To: All Interested Bidders and Plan Holders
From: Jennifer Steed, Senior Project Manager
RE: Lake Myra County Park Phase 1 (RFB#26-077)
Addendum No. 3
Date: September 29, 2026

1. See attached current plan holders list.
2. See attached Revised Bid Proposal Form.
3. See attached new and reclaimed playground equipment lists.
4. See attached Addendum No. 3 (including revised sheets) from Esse Architects.

S1.1

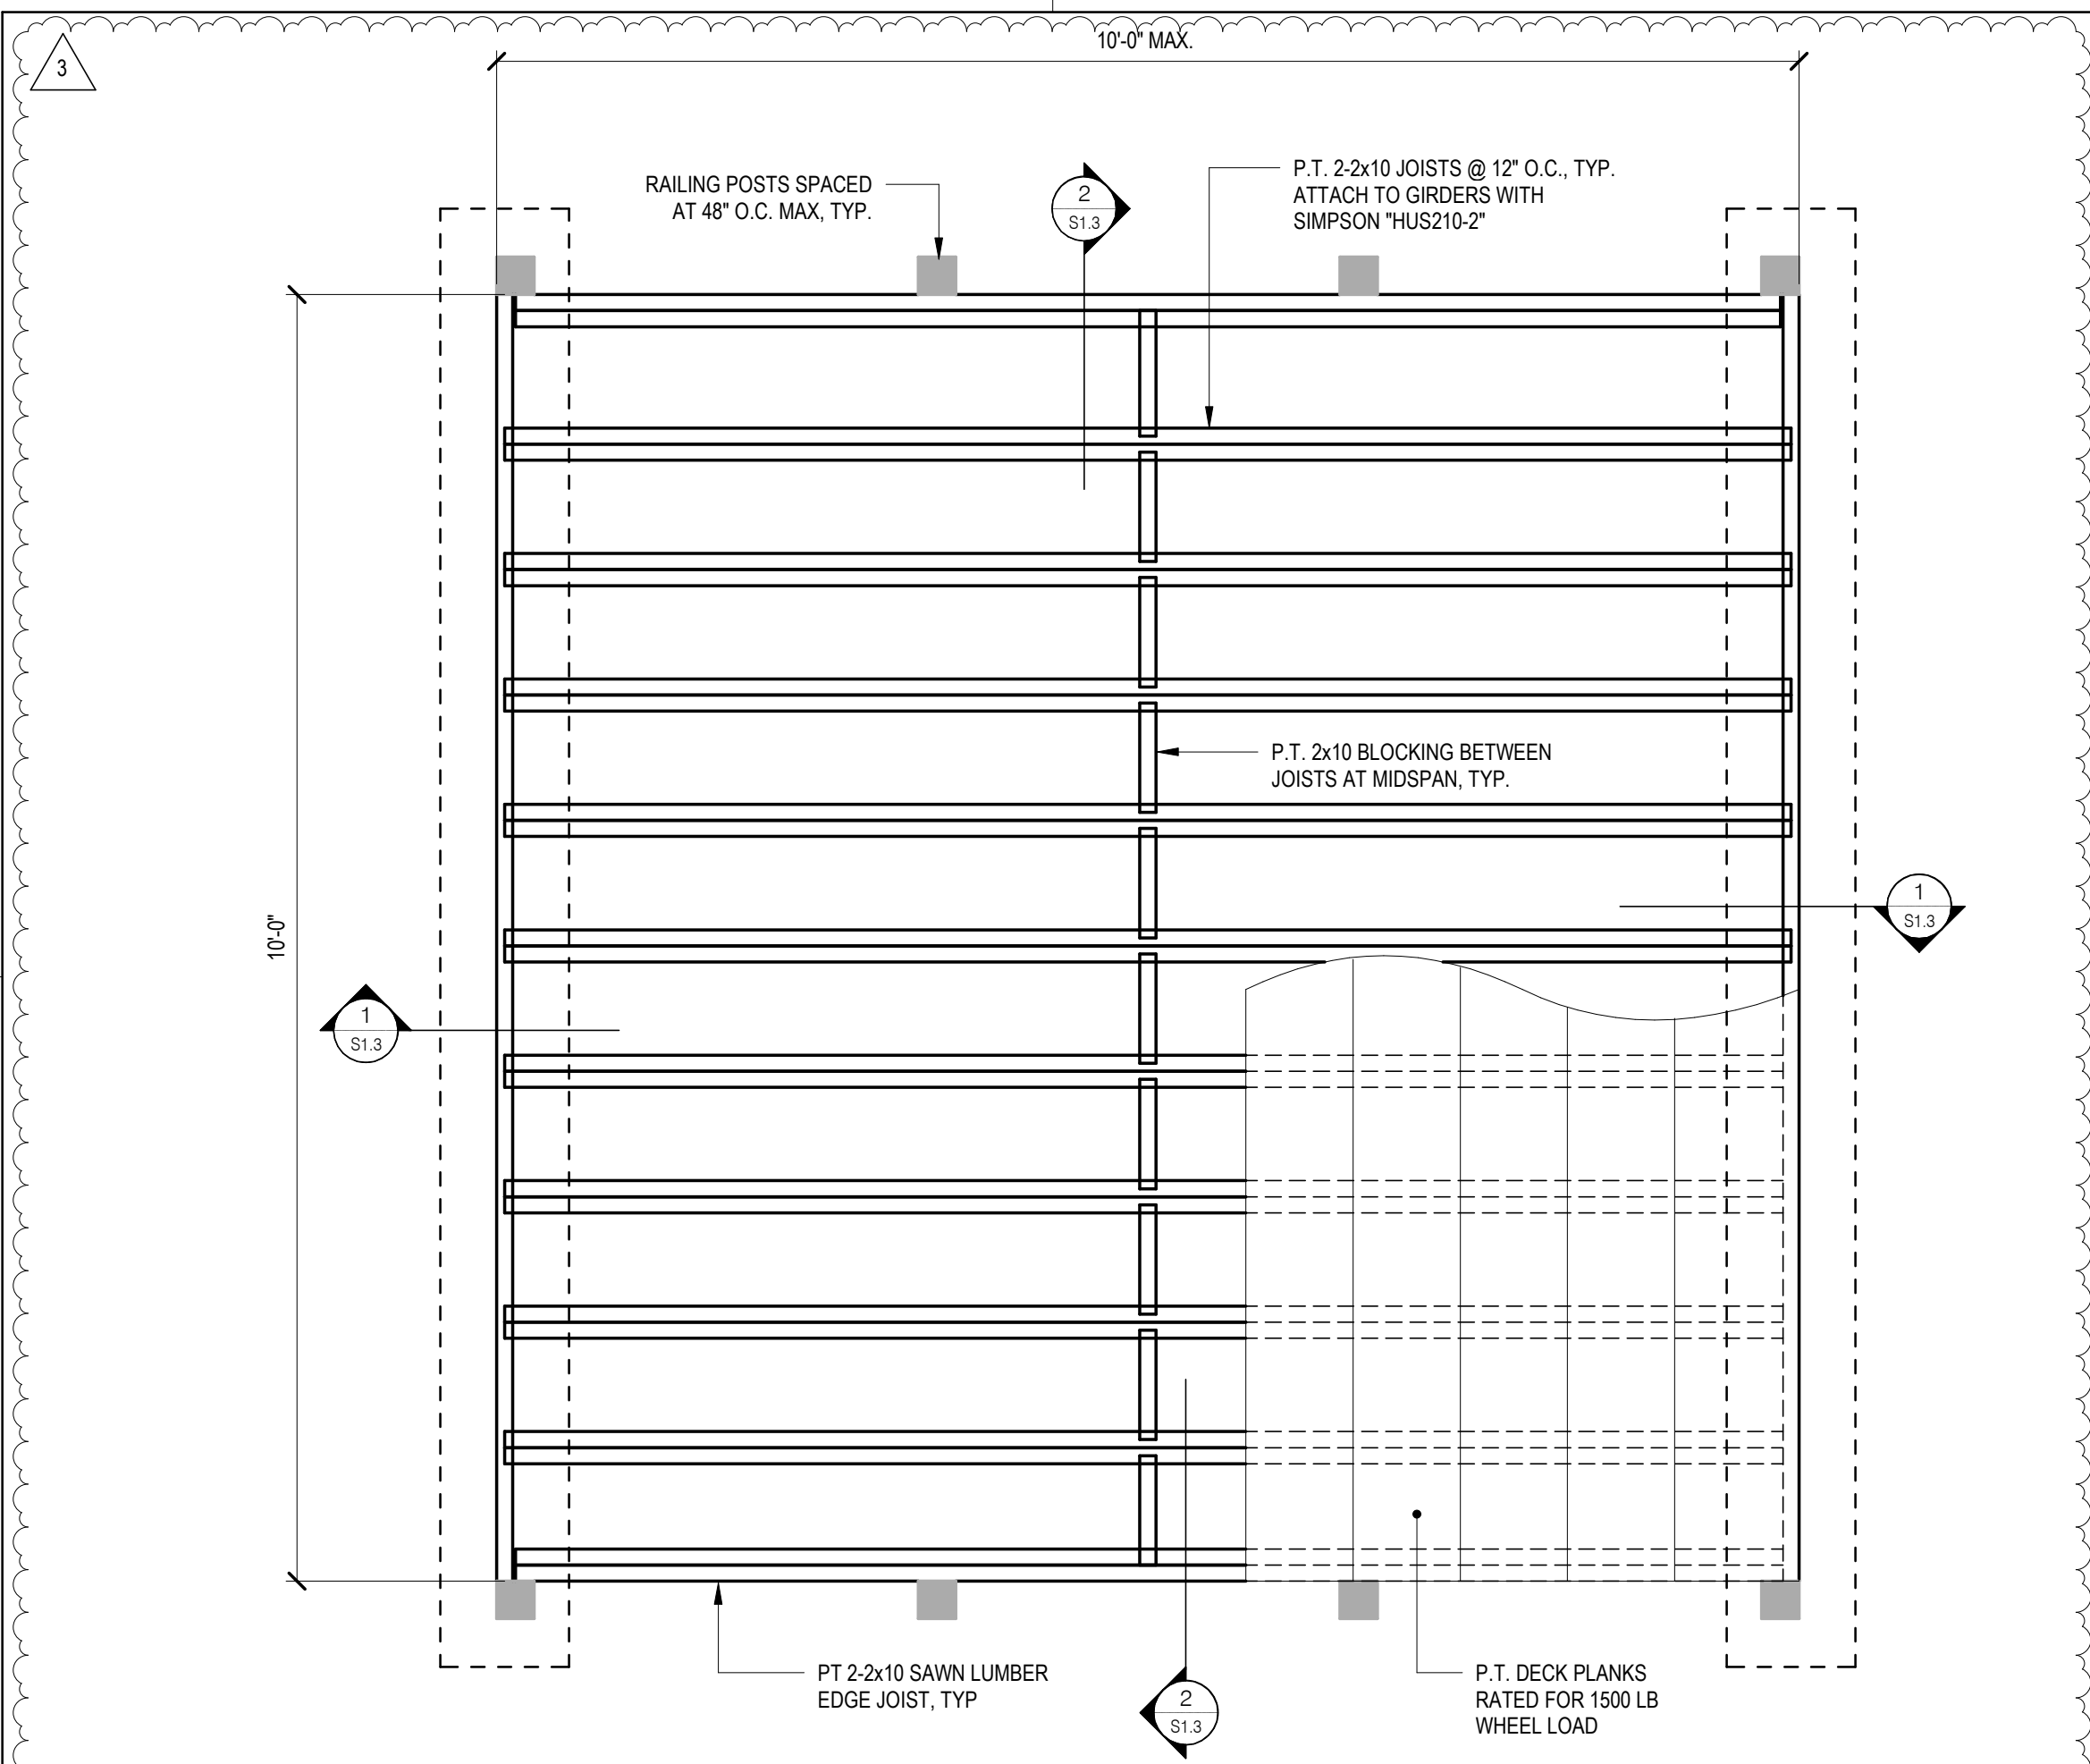
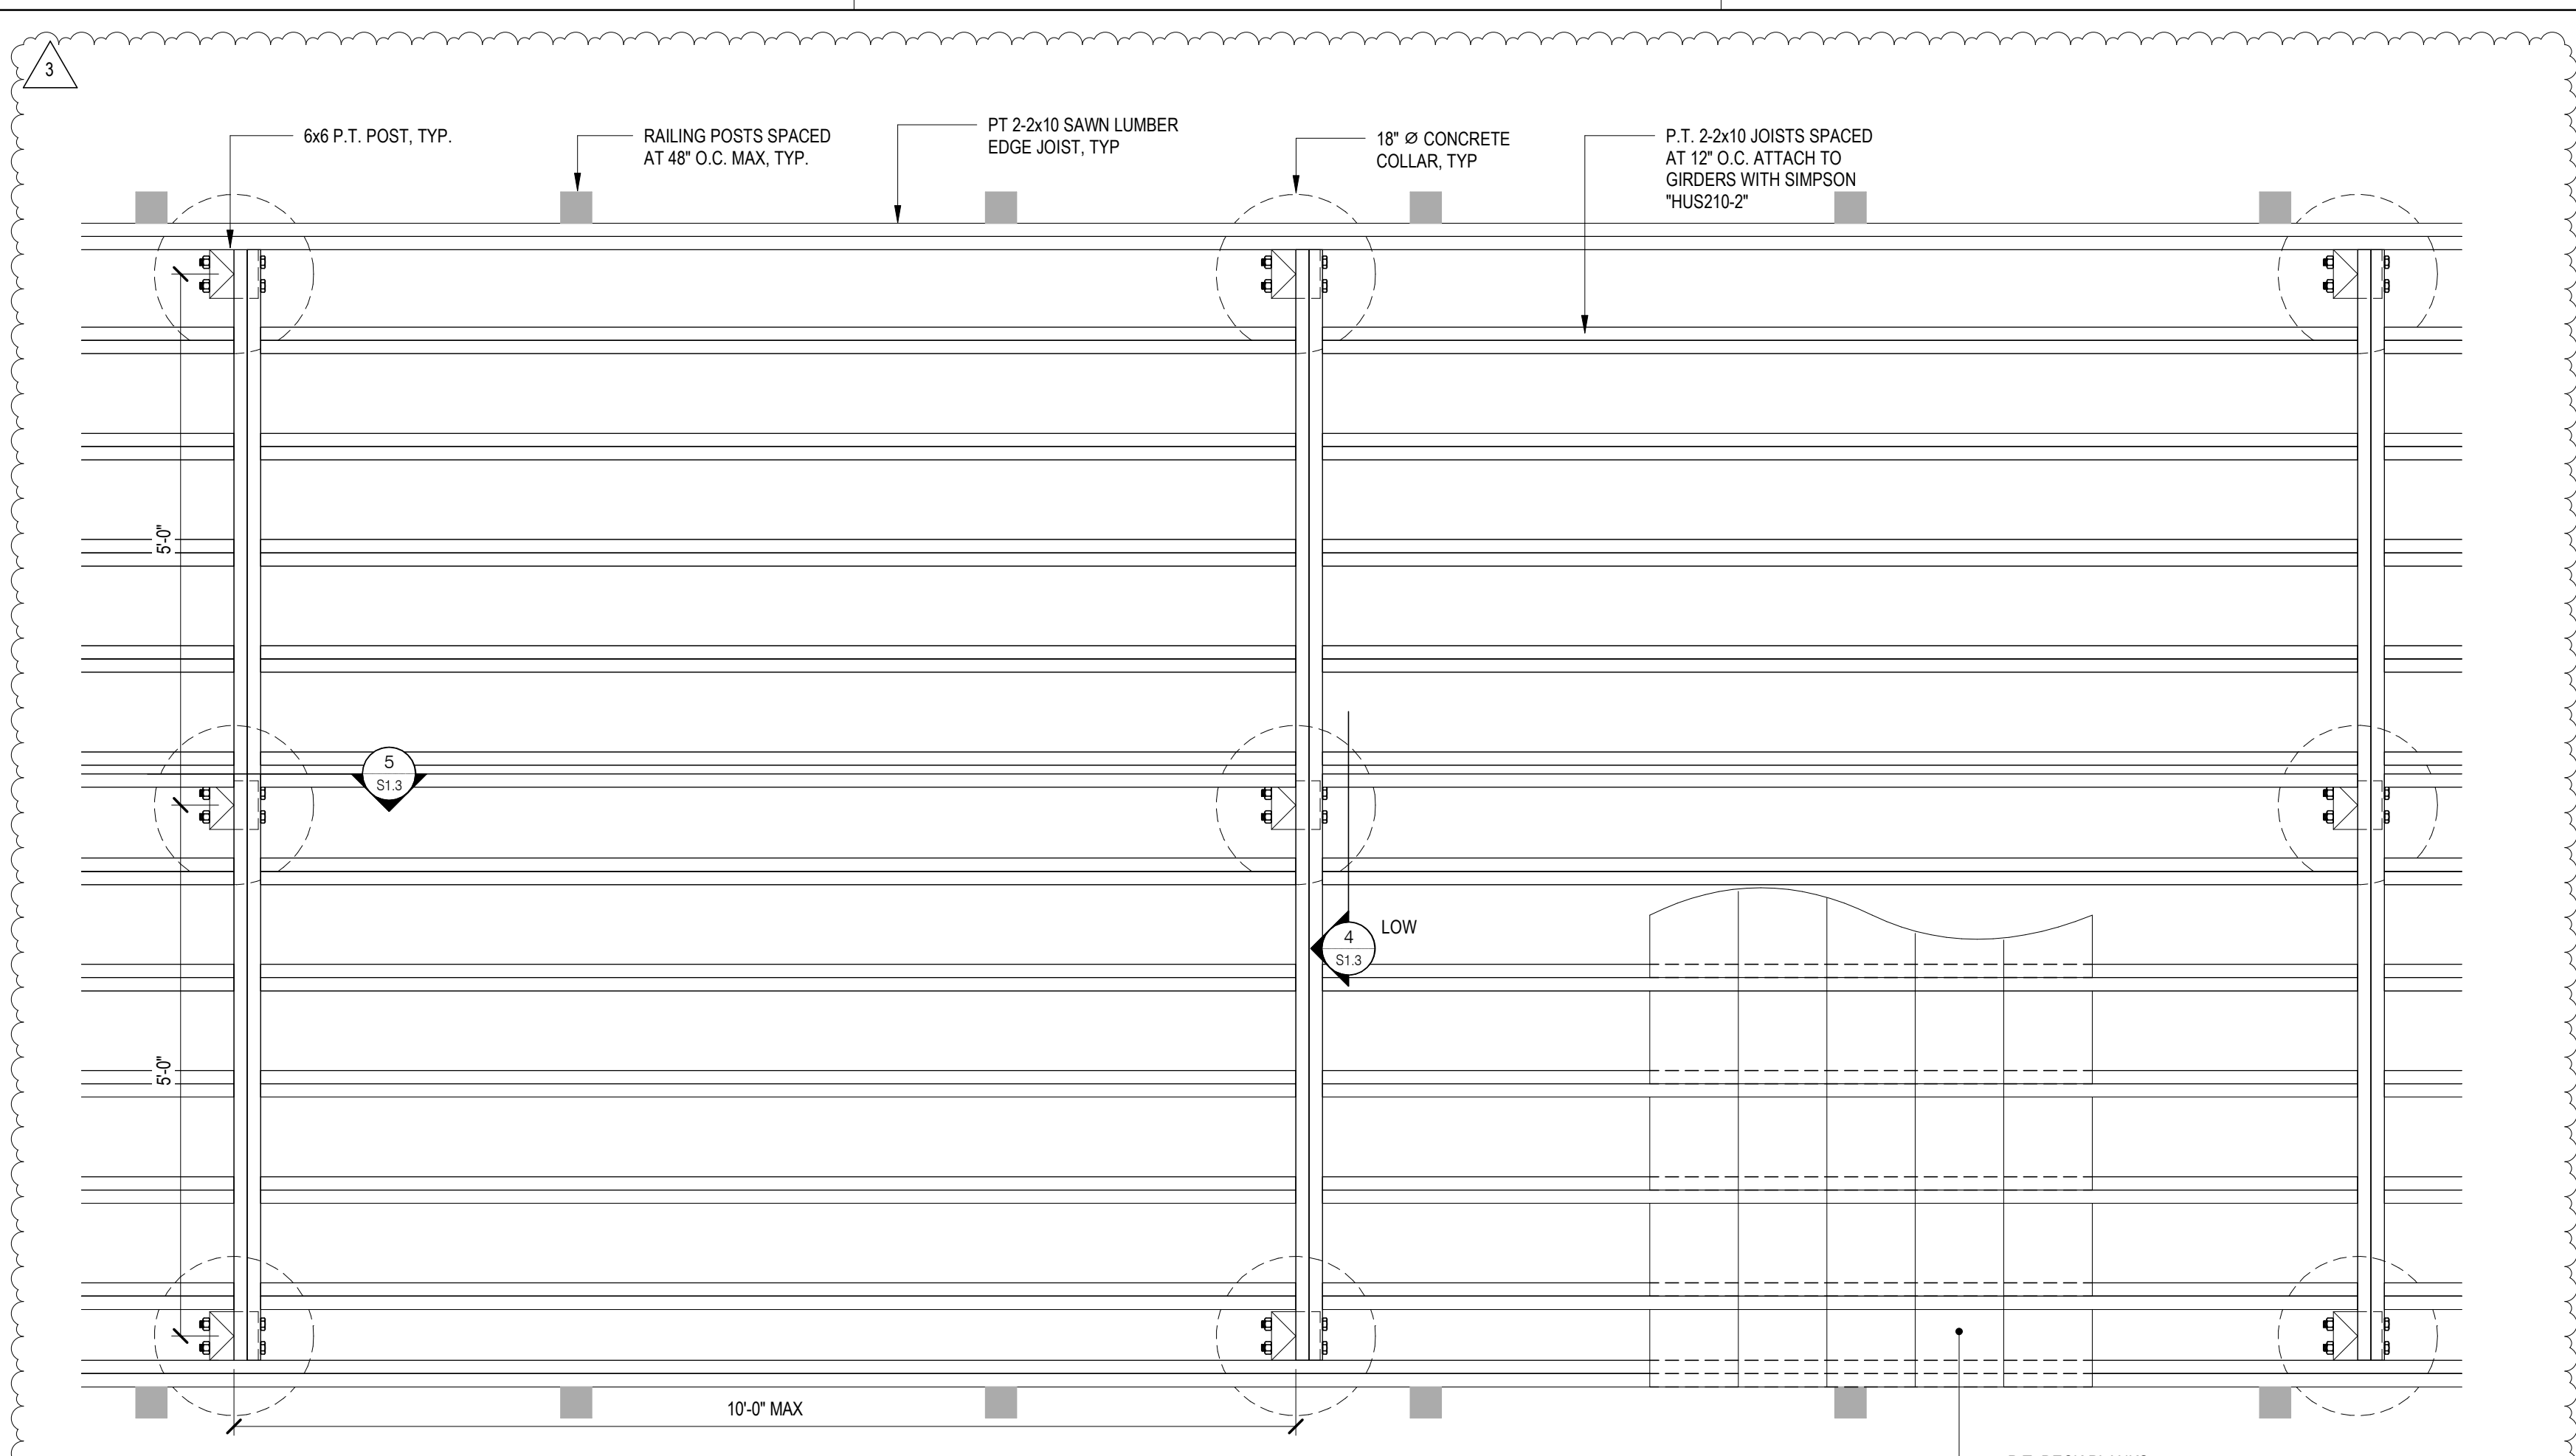
23. Bidder question: Are there any elevations that can be provided to determine pile lengths and cross bracing for the boardwalk?

- a. **Response: For bridge pile installation locations, grade at top of competent soil (lake bottom) to top of pile will determine use of structural detail 1 or 2 on S1.1. Actual elevation and grade on site will determine pile length and bracing requirements.**

2 BOARDWALK LAYOUT
SCALE: 3/4" = 1'-0"

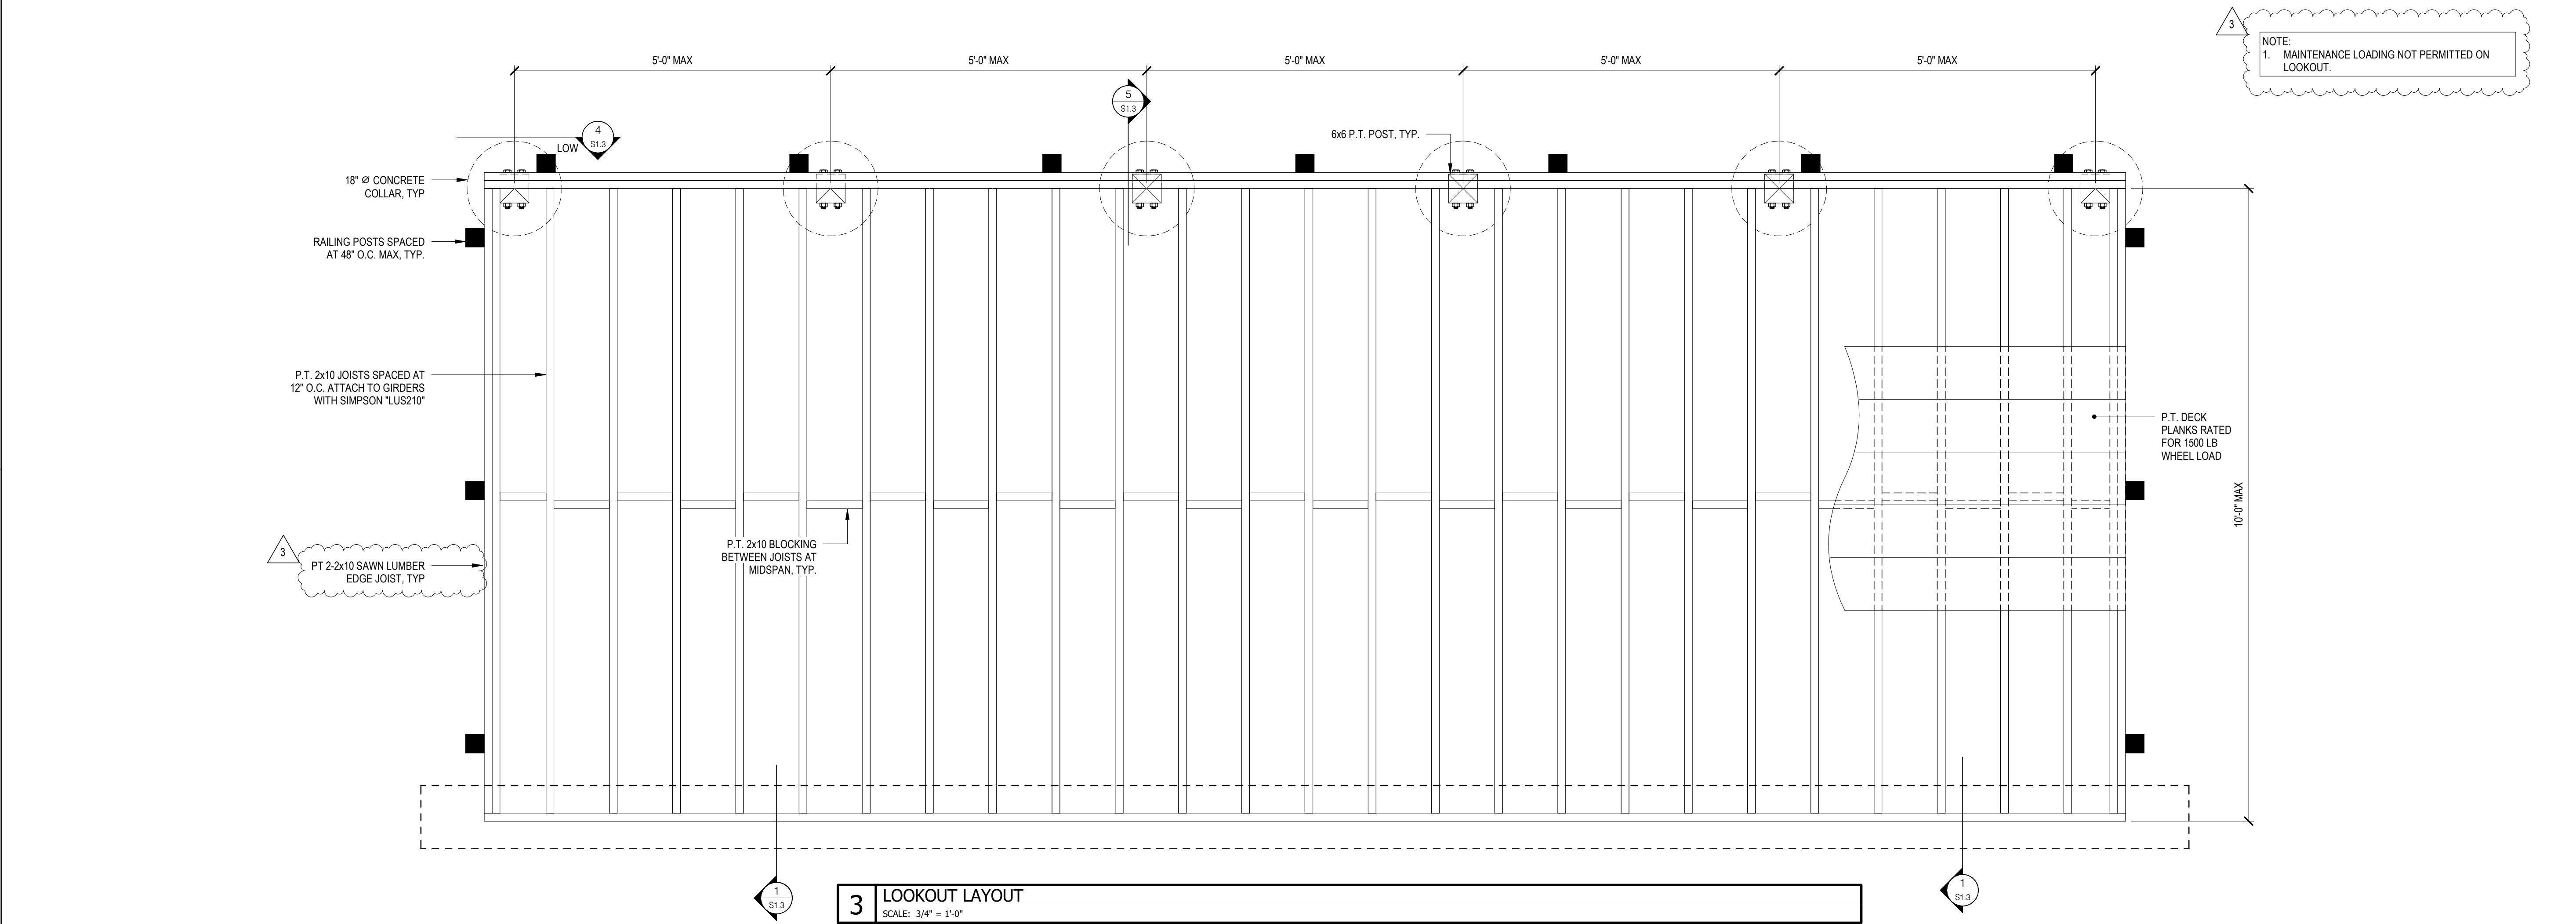
21. Sheet S1.3 — detail 4/S1.2 shows posts set in concrete. Where does this apply to the boardwalks (approach rails)?

- a. **Response: Refer to boardwalk layout on sheet 2/S1.2 for framing requirements at all boardwalk locations.**

- a. **Response: Required at any boardwalk location that requires a post in the framing layout, ref S1.2. Site and grade coordination will be required to**
